§ 68.310 Transverse balance limitations.

(Reworded and Changed)

Rationale for Harmonized Requirement:

Figure 68.310-1(a)
Illustrative Test Circuit for Transverse Balance (Analog)

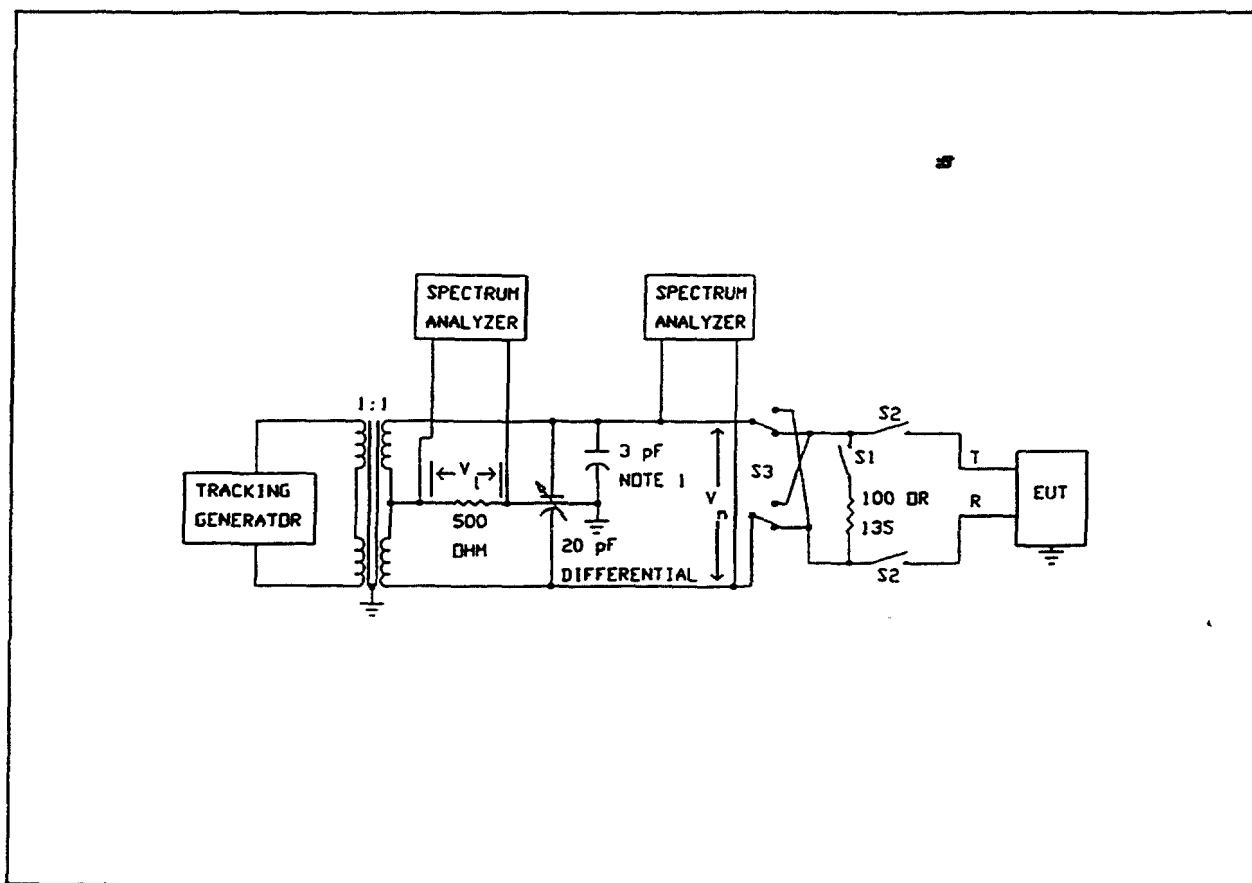
The 60 dB balance limit from 200 to 1000 Hz for analog equipment in its on-hook mode is to avoid interference with maintenance tests for facilities used for loop start and similar applications. It is inappropriate to apply the 60 dB limit to analog equipment in the off-hook state since maintenance tests are not performed in this state. Therefore the 60 dB off-hook limit currently in the rules for analog equipment has been changed to 40 dB.

Figure 68.310-5
Transverse Balance Requirements for Digital Services

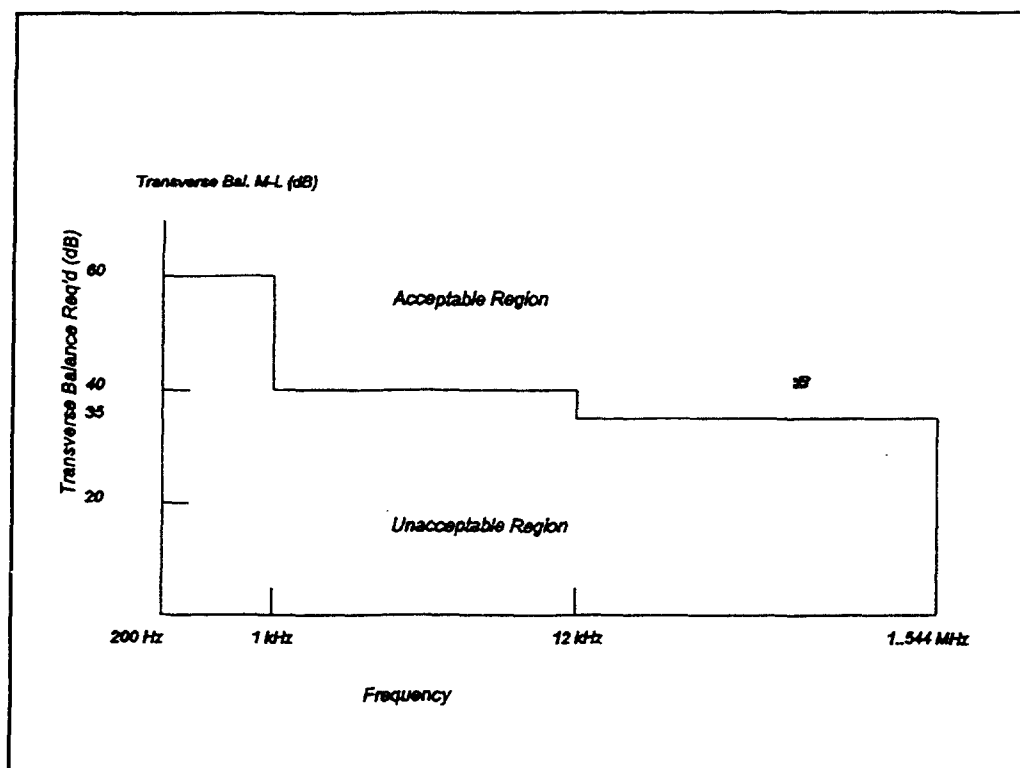
For digital equipment, two technical changes were made. First, the 40 dB limit from 12 kHz to 15 kHz has been reduced to 35 dB. This makes the 12 kHz breakpoint consistent with the longitudinal impedance specification change from 500 Ohms to 90 Ohms in Section 68.308 and in this section. The reduction in this requirement will not increase the probability of harm. The second change is in the 1.544 Mbps requirements where the lower frequency limit has been changed from 200 Hz to 10 kHz. This change was made because (1) there is little energy in the 1.544 Mbps signal below 10 kHz which can cause crosstalk interference and (2) measurements below 10 kHz require a lot more care and changes in circuitry. Thus it was concluded that there is little benefit from addressing the balance below 10 kHz for 1.544 Mbps equipment under test.
